SUBJ: Change Order #6 for Boundary Street Redevelopment Construction

Change Order 6 (CO 6) is for adjustments in the duct bank construction details, variances in structure locations and alignment. CO 6 has been reviewed by the project Construction Manager and was recommended for approval. The City of Beaufort Manager and the County Administrator have signed the change order for acceptance and City Council approved CO 6 on November 8, 2016. Therefore, it is requested that CO 6 be approved by the Committee so it can be included on the contractor's purchase order and processed for payment.

Rpt-ID: RCOCORPT	Date: 10/28/2016								
User: frailxja	Department of Transportation								
	Change	Order Report							
Contract ID: LPA07.036939A Change Order Nbr: 006 Force Acct ID: 0 Change Order Type: Standard Change Order CO Description: Boundary Street Right Side Duct Bank Impacts Zero Dollar Change Order: No						47			
Project NbrItm NbrCatgItem Code0036939RD01202119800100Item DescriptionCHANGE ORDER ITEMSupplemental Description1Boundary Street Right Side Duct Bank isSupplemental Description2	Unit Unit Price LS \$83,860.63 CO Item Description	Bid Qty 0 n Boundary S	Prev Apprvd Qty 0 Stree

user 17\Roadway\Tiger\Boundary Street\Plan Sheets\21717-DB2

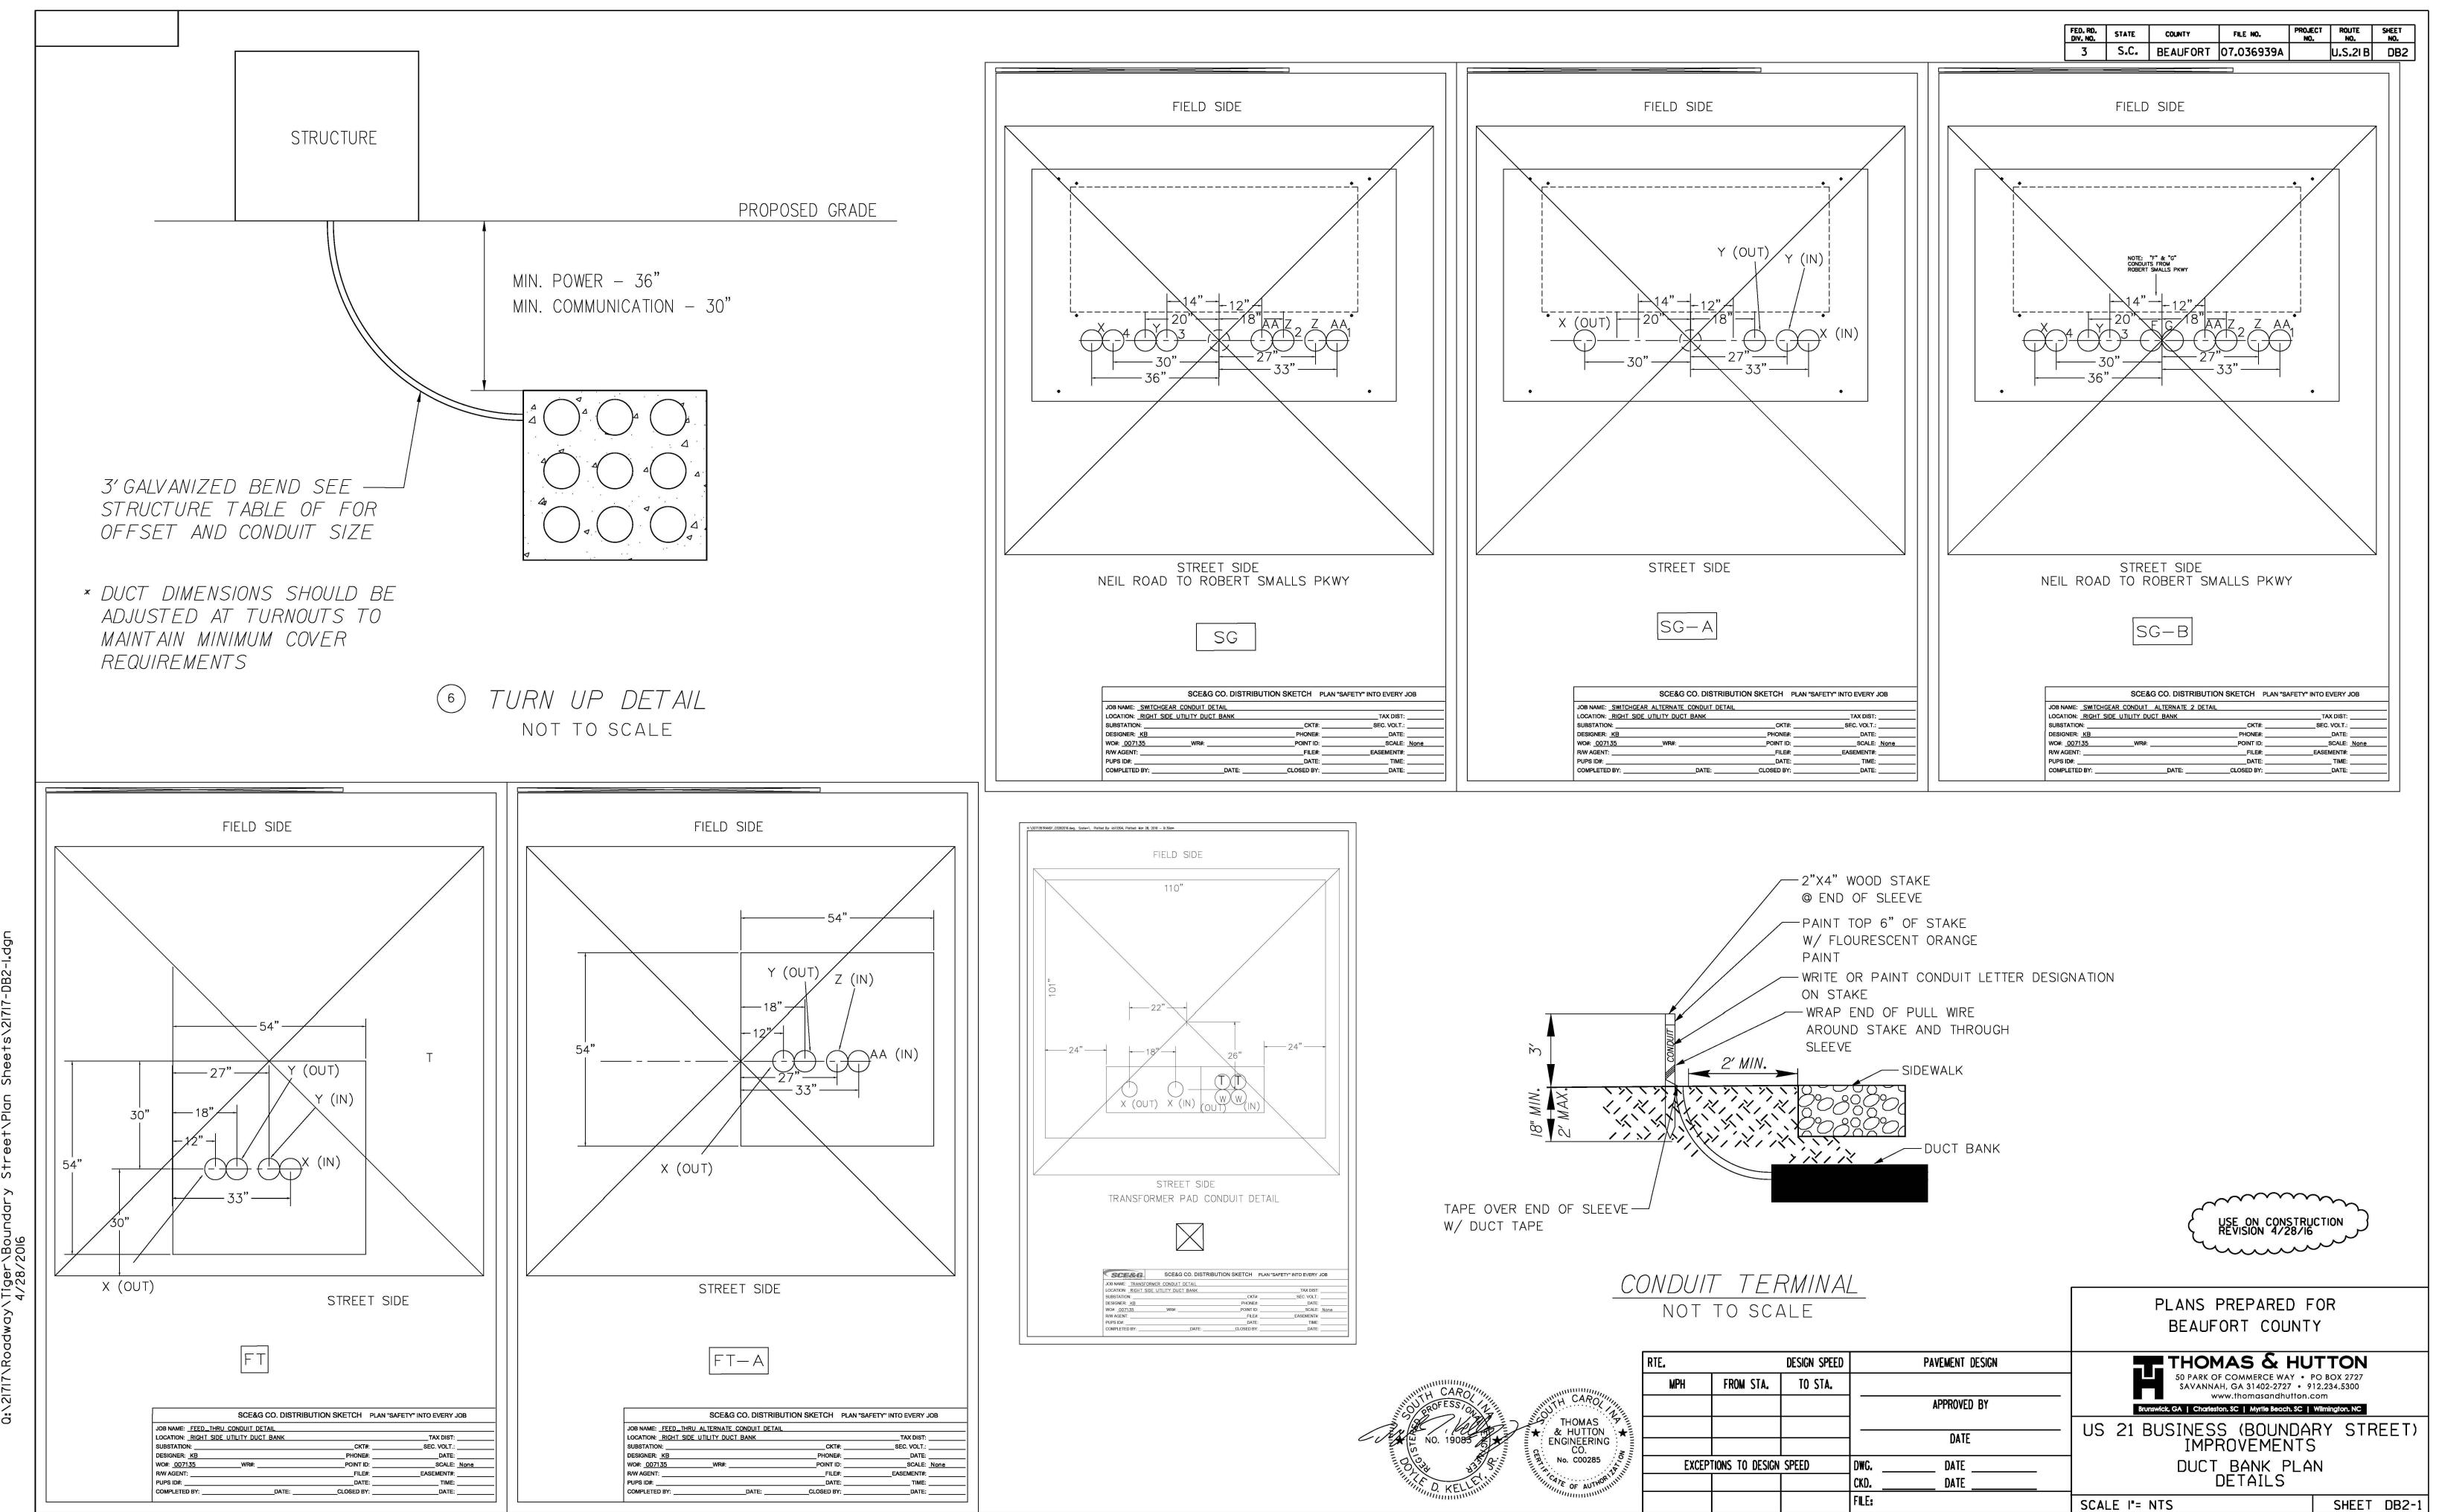
While the modification of details 3&4 reduced the amount of flowable fill on the project, it caused the construction activities to consume additional time and resources. At the commencement of the duct bank construction, SCE&G requested the bottom ducts be encased in flowable fill separate from the top communication ducts. This change added concrete cure time before the top communication ducts could be installed, backfilled, and completed. PMI anticipated an average production of 100LF per day to install details 3 &4. This change doubled the amount of construction time necessary to complete said details. The daily reports for the project will show that the 100LF per day was achievable had the design changes been clarified prior to constructing the duct bank. 2361LF of duct bank was installed on the Right side of construction centerline. It took PMI approximately 47 days to install 2361LF of duct bank resulting in an additional 23 days.

- 2. The revised equipment locations and duct configuration greatly complicated the construction of each turn out location both from a constructability and project duration perspective. Each individualized configuration caused several additional bends in an extremely crowded work area, utilizing much more time, materials and resources to perform this work. PMI assumed two turn out locations per day to complete based off the original configuration (attached). With the revised 14 structures, it took PMI an additional 15 days to complete the 14 locations. To complicate matters Structures 16 and 17 had easement procurement and utility conflicts respectfully that caused PMI to re-mobilize to finish once those issues were resolved.

- 3. The reduction in quantity on the right side has skewed the average level of effort on the project. Deleting less significant (less ducts / less complicated) work has caused the average pricing of the single duct bank line item on the project to increase in an effort to maintain the overall project average. PMI had to assume all duct configurations into a single per linear foot price as there is one pay item to cover all duct bank details. The following table depicts our subcontractors approach to each duct bank detail:

Impact	Description	Quantity	Unit	Unit Price	Total	Comment
#1 & #2	Additional Time per linear foot installed		Days			
	Additional Time per turn out location		Days			
					30	Working Days and/or 42 Calendar Days
	Additional Mobilization to structures 16 and 17	2	EA	\$1,500.00	\$3,000.00	
	Additional Daily Cost Associated with Duct Configuration		Days	\$2,669.00	\$0.00	
	Additional Daily Cost Associated with Structure Changes		Days	\$2,669.00	\$0.00	
		30	Days	\$2,669.00	\$80,070.00

#3	Detail 3 Changes					
	Length Changes	0	LF	\$64.61	\$0.00	adjust contract unit price later
	Concrete Reduction	121.6524	CY	\$113.95	-\$13,862.29	
	Detail 4 Changes					
	Length Changes	0	LF	\$73.85	\$0.00	
	Concrete Reduction	60.34614	СҮ	\$113.95	-\$6,876.44
